REMARKS

VERSION WITH MARKINGS TO SHOW CHANGES MADE

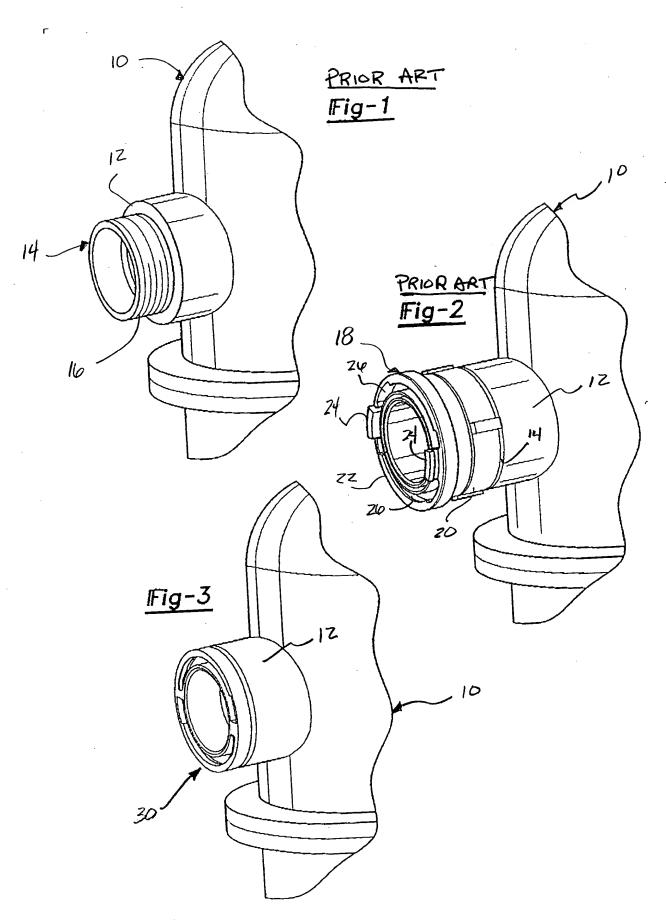
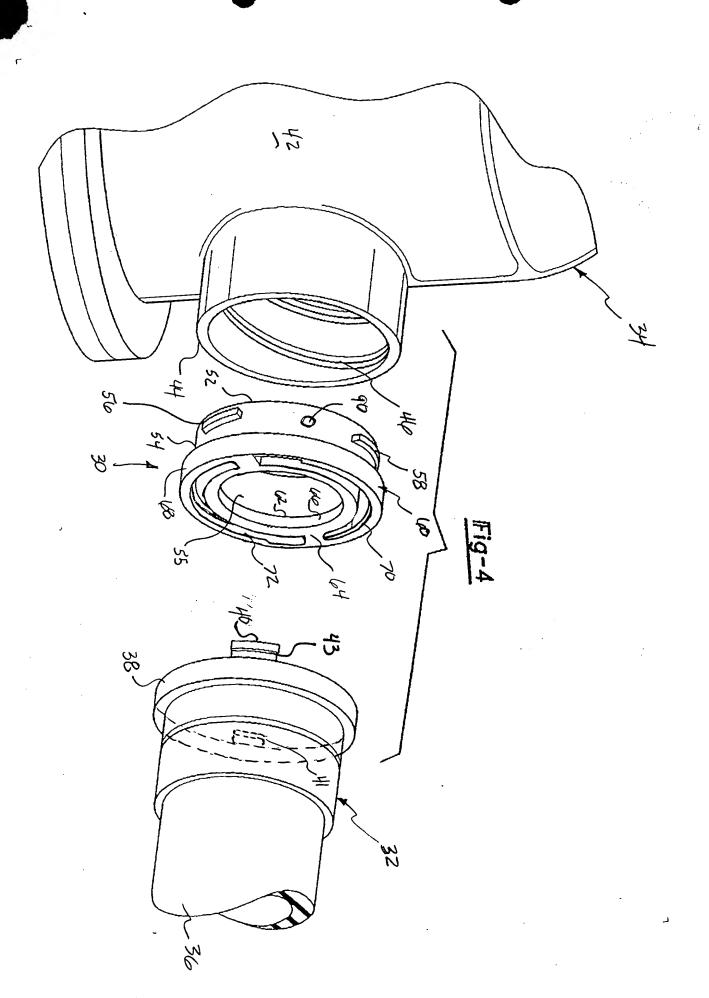
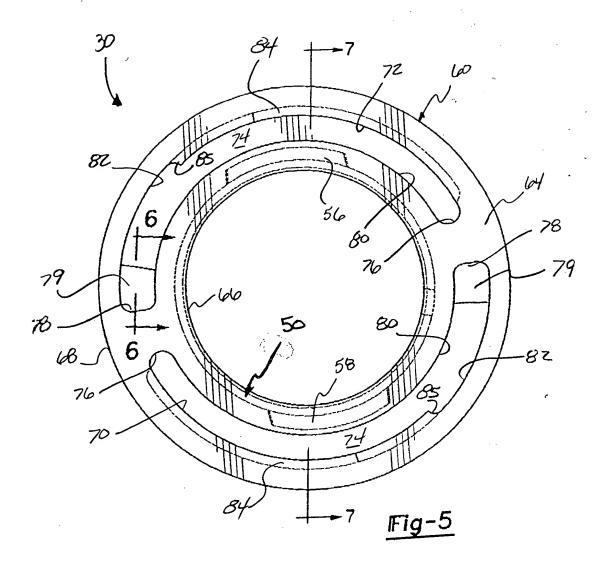
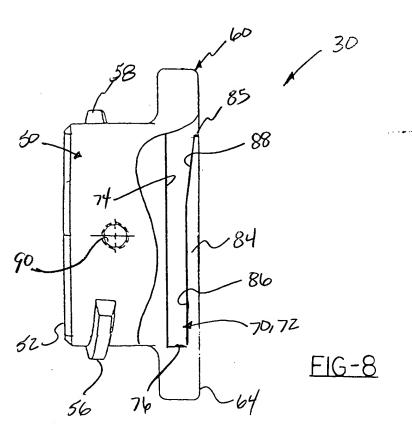
The drawings stand objected to because Figures 1 and 2 were not labeled as "Prior Art"; there was a duplicate reference number 60; and the reference sign "43" as mentioned in the specification was not shown. Each of these informalities has been corrected and new proposed drawings with the correction are submitted herewith for the Examiner's approval.
